Response to Comments on Audit Report on Measures for Mitigating Hazard to Life (Issue 2)

**First Stage of Desalination Plant at Tseung Kwan O
Audit Report on Measures for Mitigating Hazard to Life (Issue 2)**

First Stage of Desalination Plant at
Tseung Kwan O

BINNIES PROJECT NO. 4110400/40.0000.11A

Appendix A-6 OSCG Building Volume

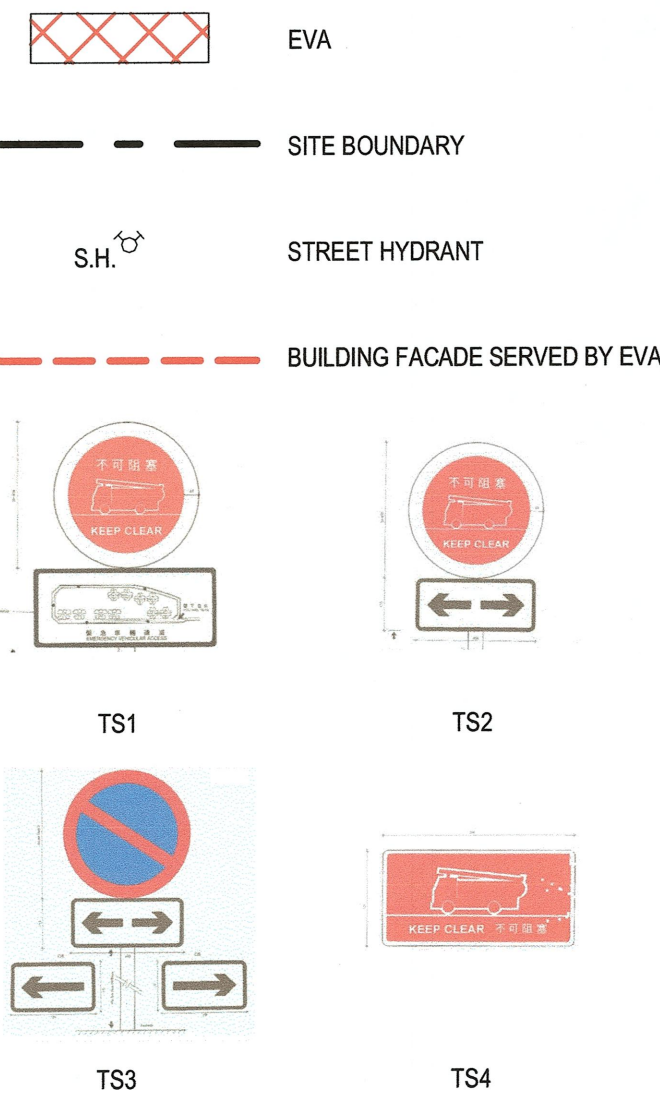
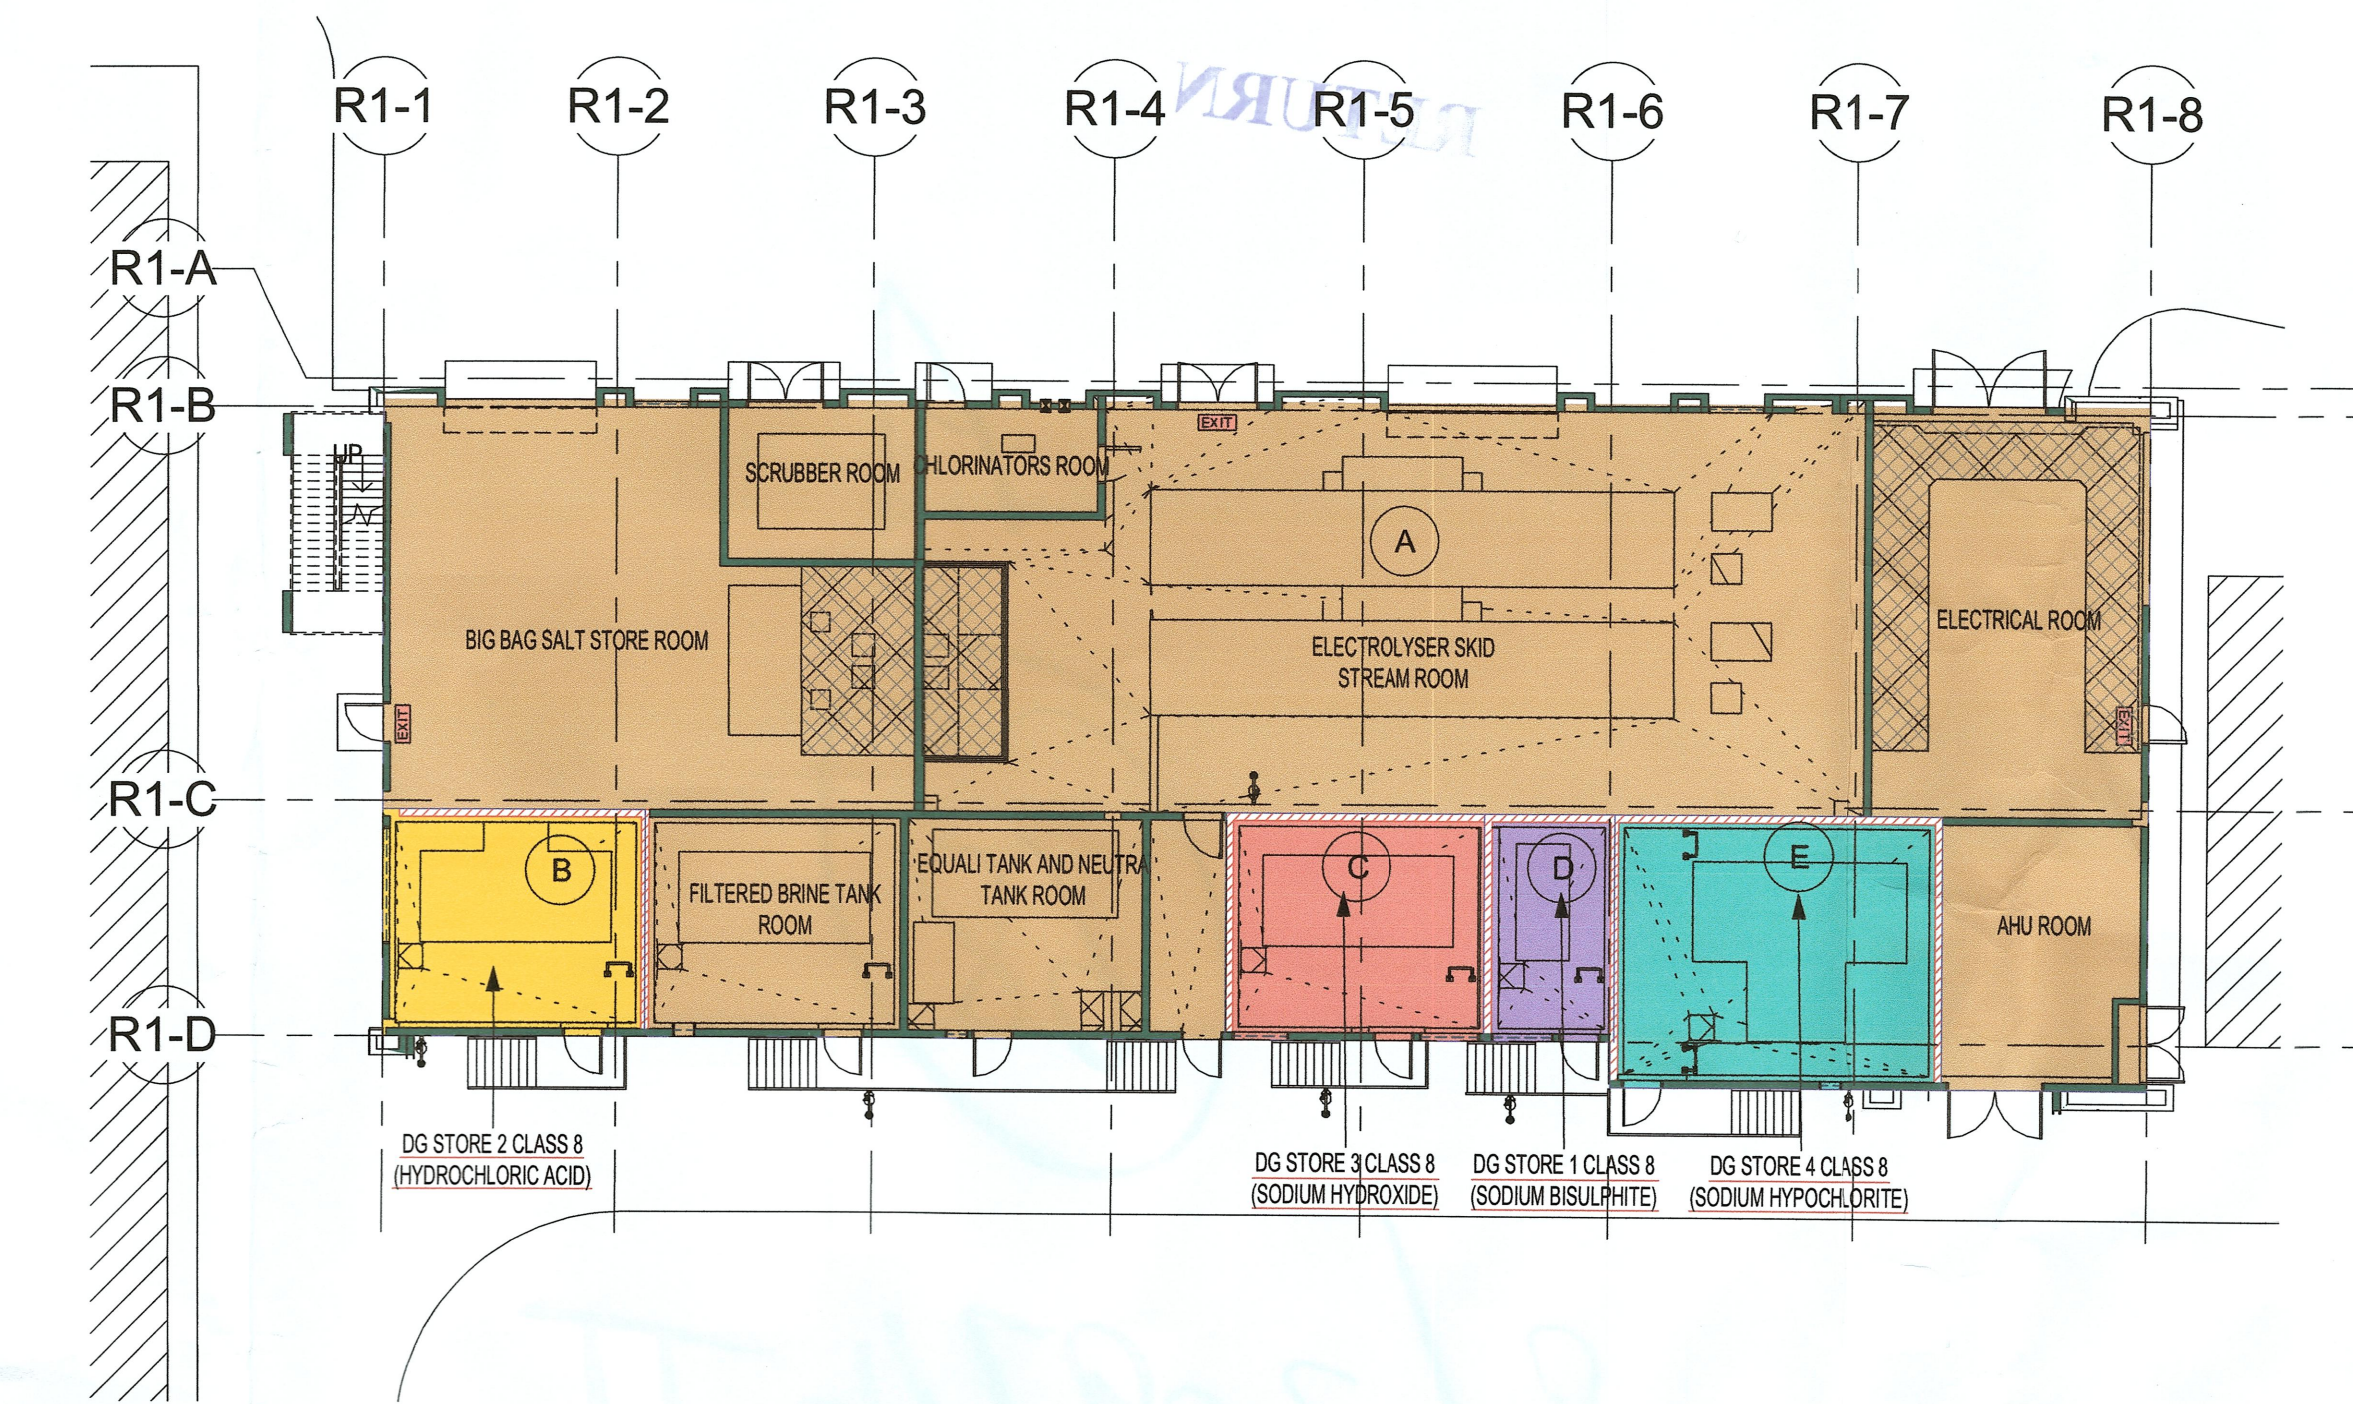
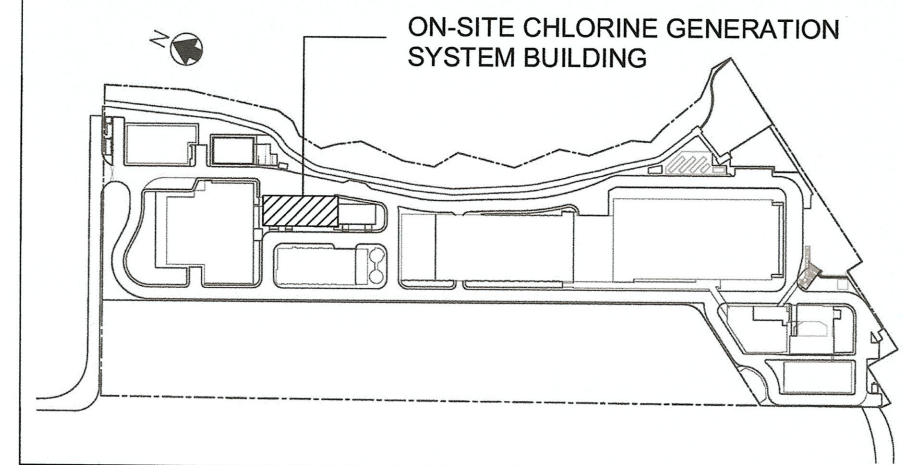
4.	Table 2-2 – (a) Item 1.3 (last column) – It is noted from the audit result that the provided on-site chlorine generation (OSCG) building volume is 5450.38 m ³ , which exceeds the design requirements stated in the 2017 ERR (i.e. 4000 m ³) and the recommendation in the 2021 DDP (i.e. 3800 m ³). In view that the OSCG building volume of 4000 m ³ was a design assumption for computation of the chlorine release rate in the 2017 ERR as stated in the 4 th column, please clarify whether such increase of OSCG building volume was reviewed / approved in any of the EIAO documents of the Project (e.g. those listed in Condition 1.7 of the EP). If not, another ERR should be submitted	Please be clarified that the volume of 4,000 m ³ is not a design requirement. It is not an upper limit nor a lower limit but is a design assumption used in the 2017 ERR. Text has been added in Table 2.2 (Item 1.3) to adequately address the environmental implications of such change and explain to the public that the change will not cause any adverse hazard to life impact. Implications of the changes have also been reviewed in S13.2.11 of a separate ERR (Issue 1) for “Agreement No. CE 92/2022 (WS) Second Stage of Desalination Plant at Tseung Kwan O - Investigation, Design and Construction” (2023 ERR) submitted to EPD. Based on the technical comments

No.	Comments	Response
	separately to review the implication of the revised design (e.g. whether the chlorine release rate would be changed due to the increase in volume of the OSCG building) before implementation.	received from the EPD on 18 Oct, 1 Nov and 8 Nov 2023, EPD has no comment on S13.2.11 of the 2023 ERR, which states that such change of building volume would not cause additional adverse hazard to life impact.
